LINCOLN CITY/LANCASTER COUNTY PLANNING STAFF REPORT

for May 26, 2004 PLANNING COMMISSION MEETING

P.A.S.: Change of Zone #04017
Special Permit #04011

BOULDER RIDGE

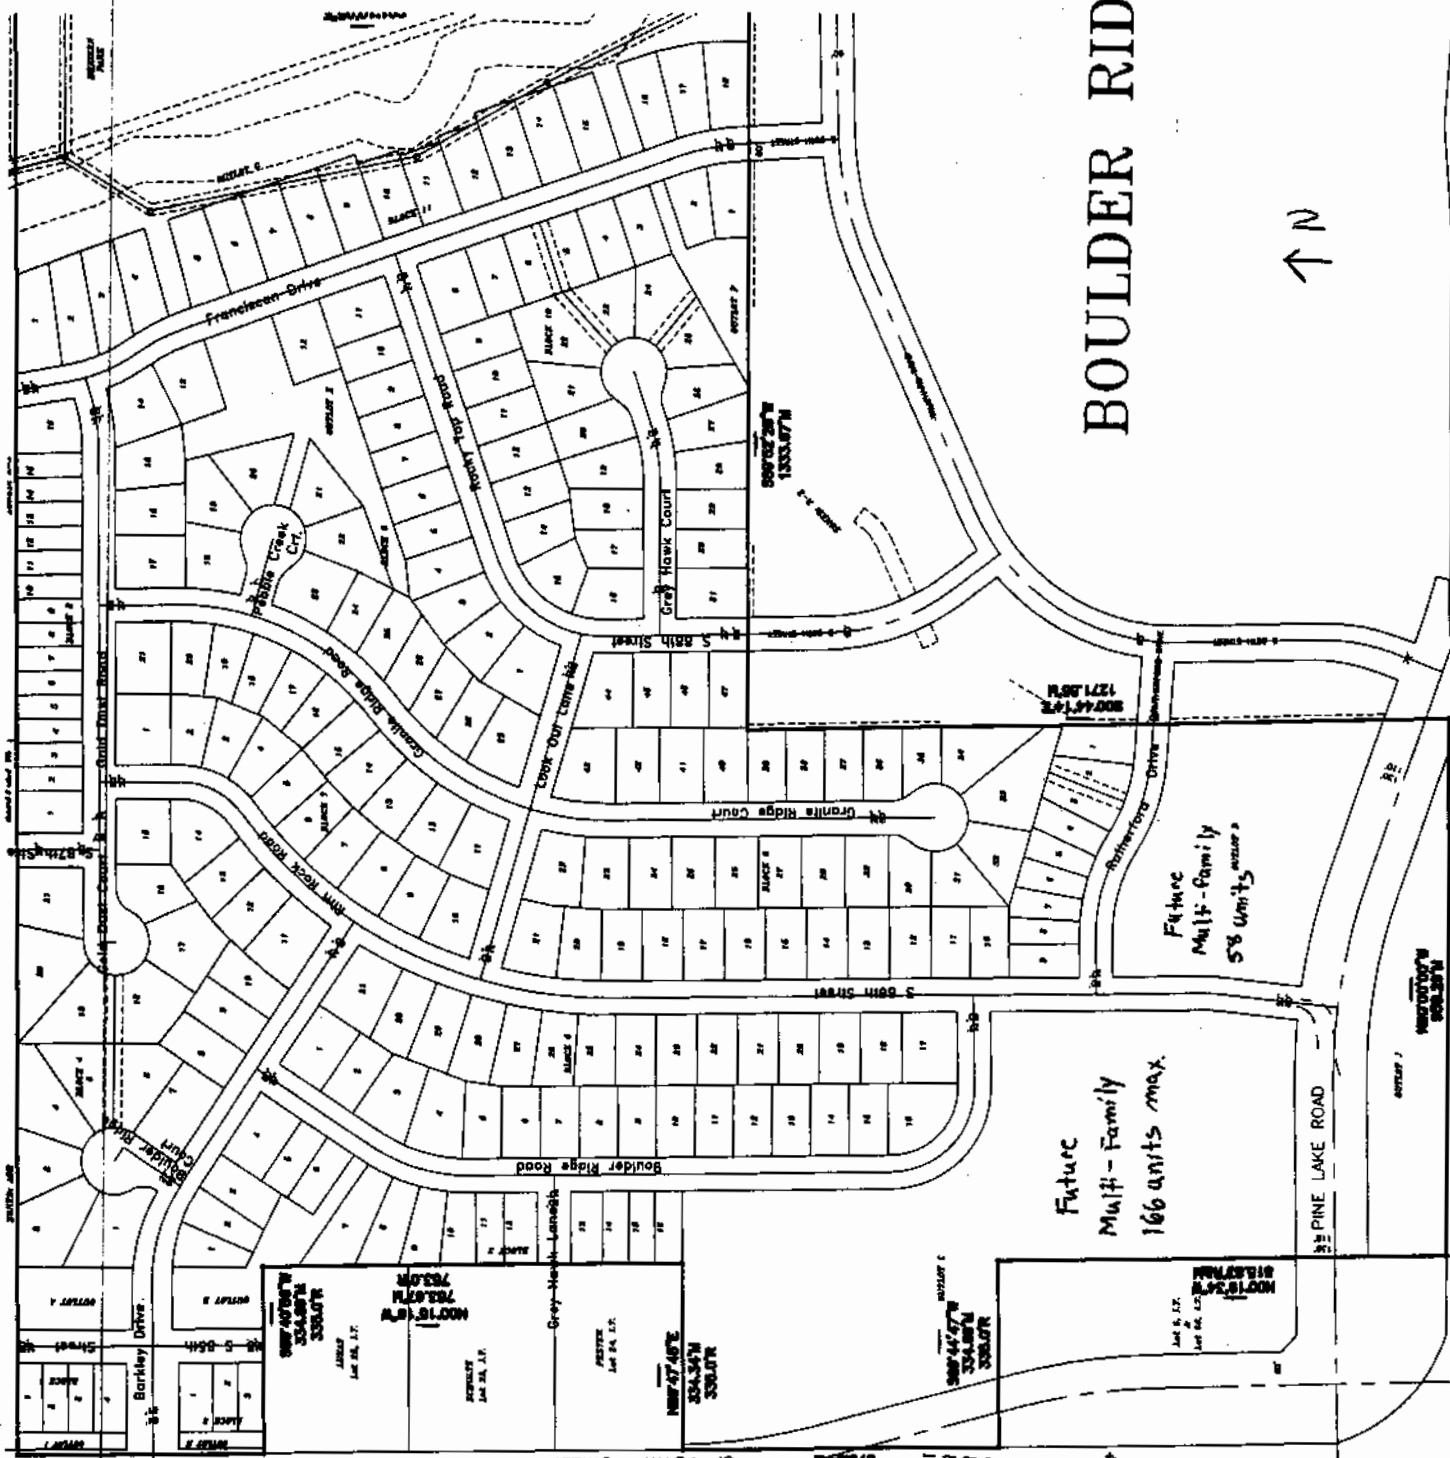
(1.1) There are a number of locations where the sewer is to run opposite street grades, requiring a waiver of design standards. Public Works would approve this waiver provided that maximum depths are not exceeded as a result of the waiver. Information needs to be provided showing the locations where the waiver applies and showing that the maximum 15' depth is not exceeded.

(3.1) Show the grading for the new 84th Street and how the proposed site grading along 84th will match these grades.

(3.2) There are numerous locations on the grading plan that show excessively flat lots or show drainage flowing down shared rear lot lines. As lots in these areas are built upon, the assumed drainage paths are frequently blocked during the home construction process causing drainage problems for the future home owner. Public Works recommends that the grading plan be revised to show a minimum of 3% slope from rear to front on all lots. Blocks 5, 7, 9, and 10 show lots with these potential drainage problems.

(3.3) Drainage swales are required for conveyance of the 100yr flow between Lots 20-21 Block 9 and between Lots 24-25 Block 10. Typical cross sections and capacity calculations need to be shown. The grading plan needs to be revised to match the cross sections provided.

(3.4) The location of the proposed 42" storm sewer between Lots 4&5 Block 11 with respect to the proposed sanitary sewer is unsatisfactory. Design standards state that a minimum of 10' separation needs to be provided between sanitary sewer and storm sewer. The site plan and utility plan need to be revised to meet design standards.

(3.6) The 100yr flood elevations are shown on the grading plan, however, no supporting information has been provided as previously requested. Given the proximity of proposed lots to the Antelope Creek Floodway, supporting calculations and documentation needs to be provided for the flood elevations shown.

(3.7) The minimum elevations shown for lots in Block 3 should be revised to 1381.75. This elevation represents the approximate emergency overflow elevation for the proposed detention pond. All other minimum opening elevations need to be revised to 1' above the 100yr elevations shown for the proposed detention ponds and along Antelope Creek as per design standards.

(3.8) There appears to be an error on the grading plan concerning the proposed storm sewer that is shown between Lots 4&5 Block 11. The plan shows a 42" pipe draining to a 36" pipe. One or both of the pipe size labels needs to be revised to match the correct size indicated in the drainage study.

(4.1) The site plan shows portions of Barkley Drive between South 85th Street and Boulder Ridge Court to have approximately 6' of separation between the back of curb and the ROW line. This is unsatisfactory. If a wider street section is to be constructed the ROW needs to be widened appropriately providing the standard 16.5' from back of curb to ROW line to allow for the construction of water mains, sanitary sewer, and other utilities that are typically located in this area. Also, the median in Barkley Drive creates poor alignment with the existing Barkley Drive on the west side of 84th.

(4.2) The intersection of South 86th Street and Pine Lake Road is shown to have left in and no left out. This intersection configuration is not approved by Public Works as they do not appear necessary and may cause an insufficient left turn pocket length in Pine Lake Road and should be revised to show a full median across the intersection.

(4.3) The intersection of Barkley Drive and 84th Street as shown would require a waiver of design standards for maximum grade on the approach to a major street. This waiver has not been requested and justification has not been provided. The profile for Barkley Drive needs to be revised to show the proper platform length unless sufficient justification is provided and approved by Public Works.

(4.4) The intersection at 85th and Barkley Drive as shown would require a waiver of design standards for maximum grade of 3.0% on the approach to an intersection. This waiver has not been requested and justification has not been provided. The profiles need to be revised to show the proper platform length unless sufficient justification is provided and approved by Public Works.

(4.5) Right turn lanes need to be shown in Pine Lake Road at 86th Street and in 84th Street at Barkley Drive. The right turn lanes are not impact fee facilities and should the responsibility of this developer.

(4.6) The dimension note in the north west corner of the plat concerning the 10' of future ROW needs to be revised to say "10' of additional ROW to be dedicated to the city".

- 1.1.1 a fire hydrant on Granite Ridge Rd. between Look Out Lane and Pebble Creek Cir.
- 1.1.2 Show a street from S. 85th St. or Boulder ridge Rd. to provide access to Lot 61 I. T. and Lot 66 I. T.
- 1.1.3 Show a conceptual street lay out for Lots 23-25 I. T.
- 1.1.4 Outlot I combined with Lots 1-4, Block 1.
- 1.1.5 Outlot H combined with Lots 1-3, Block 2.
- 1.1.6 Granite Ridge Ct. extended to Rutherford Dr.
- 1.1.7 the existing house on Lot 16 I.T.
- 1.1.8 revise note 13 . change 227 to 224 multi-family units and change 9 outlots to 10 outlots.
- 1.1.9 change total unassigned units to 240 in the density calculations table
- 1.1.10 revise note 16 to state Outlots C & D will be maintained by the developer.
- 1.1.11 revise the legal description and boundary of the plat.
- 1.1.12 show a pedestrian easement over the sanitary sewer easement from Grey Hawk Ct. to Franciscan Dr.

1.1.13 change the note in the northwest corner of the plat to read, "10' of additional ROW to be dedicated to the City."
